SERVICE BULLETIN

DATE: 2 SEPTEMBER 1980

REPLACEMENT OF PN 369A1602 TAIL ROTOR DRIVE FORK HINGE BOLT AND PN 369A1603 NUT; NEW ASSEMBLY PROCEDURE FOR TAIL ROTOR HUB AND DRIVE FORK UNIT; PERIODIC CHECK OF FLAPPING HINGE BOLT PRELOAD

Figure 1. Assembly and Shimming - Fork Conical Type Bearings

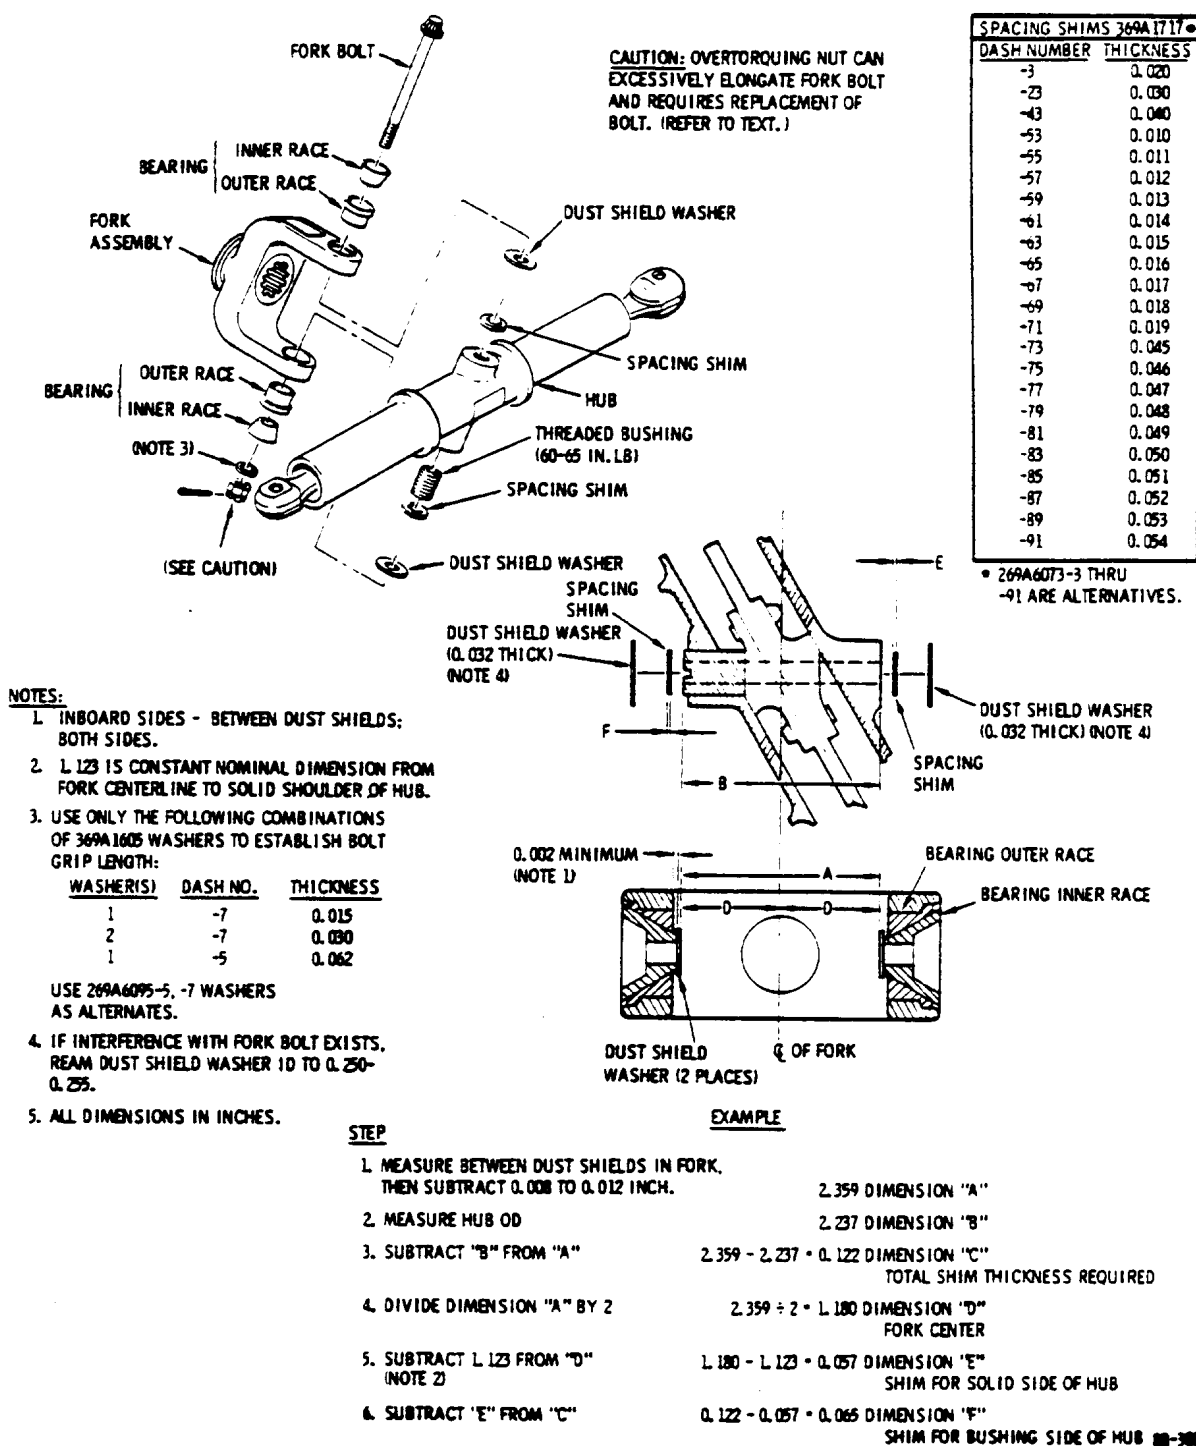
- (a). Determine that fork conical bearings are serviceable and bearing outer races are installed in fork.
- (b). Determine spacing thickness for centering the hub in the fork as follows (see example in Figure 1):
 - 1). Temporarily install bearing inner races of fork.

- 2). Temporarily insert new PN 369A1602 fork bolt through fork bearings and dust shields; install VCU0001 or 79325-428 nut. Snug nut only enough to remove all looseness.
- 3). Press dust shields firmly against bearing inner races. Measure distance between dust shields, then subtract 0.008 to 0.012 inch. Record this as dimension "A".
- 4). Measure and record distance from solid shoulder of hub to opposite side (outer face of threaded bushing). Label this dimension "B".
- 5). Subtract dimension "B" from dimension "A" to determine total required shim thickness (dimension "C").
- 6). Divide dimension "A" by 2; label this dimension "D".
- 7). Subtract 1.123 inches from dimension "D" to determine shim thickness for solid state of hub (dimension "E").

- 8). Subtract dimension "E" from dimension "C" to determine shim thickness for bushing side of hub (dimension "F").
 - 9). Remove nut and fork bolt, while following bolt through fork with chamfered end of alignment pin.

- (c). Reassemble hub and drive fork assembly as follows:
- 1). With the respective bearing inner race installed, start new PN 369A1602 fork bolt through the bearings. Place spacing shims of correct combined thickness with dust shield washer at solid side of hub as shown in Figure 1. Position hub in fork; then slowly displace the alignment pin by pushing the bolt through fork and hub until bolt is flush with face of bushing. Light tapping with a soft mallet may be required.

- 4). Install washer(s) and VCU0001 or 79325-428 nut on bolt. Use washer combinations shown in Figure 1 to establish bolt grip length and cotter pin hole alignment.
- 5). Measure length of fork bolt with zero torque applied. Torque nut to elongate bolt 0.008 to 0.011 inch and install cotter pin. If bolt is inadvertently elongated over 0.011 inch, discard bolt and install new one.
